SI B11 06 13
Engine

This Service Information bulletin supersedes SI B11 06 13 **dated October 2013**.

Service Action: Retrofit Bracket for EGR Cooler

E70 (xDrive35d)

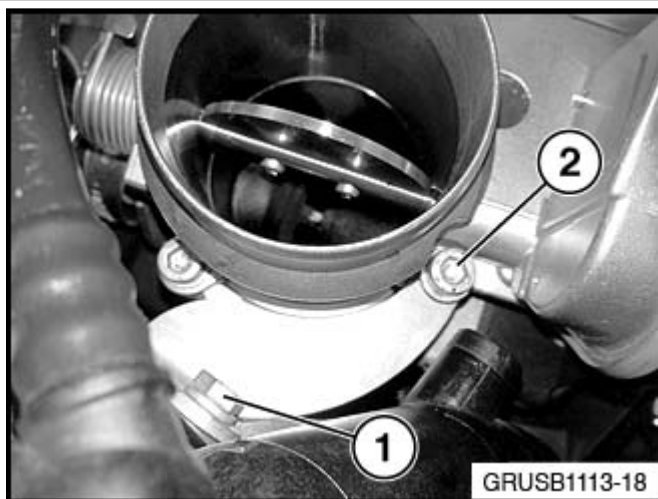
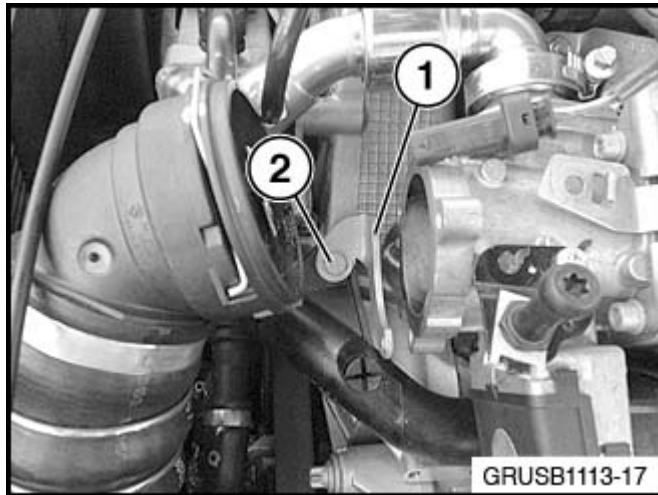
<p>Install bracket P/N 13 54 8 576 446 (1) to the cylinder head using the bolt P/N 07 11 9 904 527 (2). Leave this bolt finger tight until after the throttle valve is reinstalled. NEW Note: If the EGR cooler is leaking at the flexible elbow, replacement is necessary.</p>
--	--

Reinstall the throttle valve and snug down all three throttle valve screws. Torque the two screws that are not attached to the new bracket to specification (8Nm). Tighten down the bracket bolt on the cylinder head (1) to 8Nm. Tighten the screw (2) holding the bracket to the throttle to 8 Nm.
